## Product Change Notice (PCN)

PCN Number: **PCN-0456172R-01**

Product(s) Affected: *PJ-040CH*

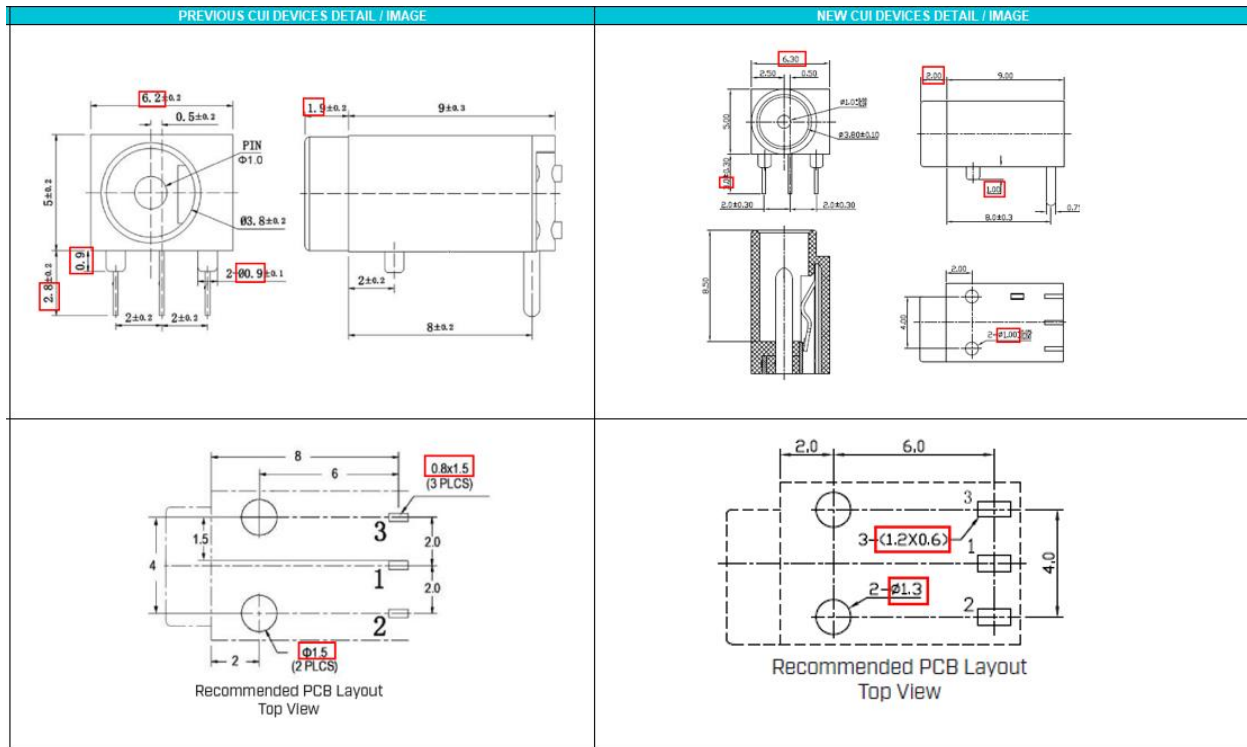
Description of Change: *New Factory Location. Product re-engineered for improved manufacturability and production yield. See image below for reference and check CUI Devices website for updated drawing. Cosmetic differences may be visible and not affect the form fit and function of the product.*

PREVIOUS CUI DEVICES DETAIL / IMAGE			NEW CUI DEVICES DETAIL / IMAGE		
DESCRIPTION	MATERIAL	PLATING/COLOR	DESCRIPTION	MATERIAL	PLATING/COLOR
center pin	brass	silver	center pin	brass	silver
terminal 1	brass t=0.25	silver	terminal 1	brass t=0.25	silver
terminal 2	brass t=0.25	silver	terminal 2	SUS301 t=0.25	silver
terminal 3	brass t=0.25	silver	terminal 3	brass t=0.25	silver
cover	PBT (UL94V-0)	black	housing	PAGE (UL94V-0)	black
housing	PBT (UL94V-0)	black

<p>MATING PLUG Jack Insertion Depth <b>8.0 mm</b></p>	 <p>MATING PLUG Jack Insertion Depth <b>8.5 mm</b></p>
---	--
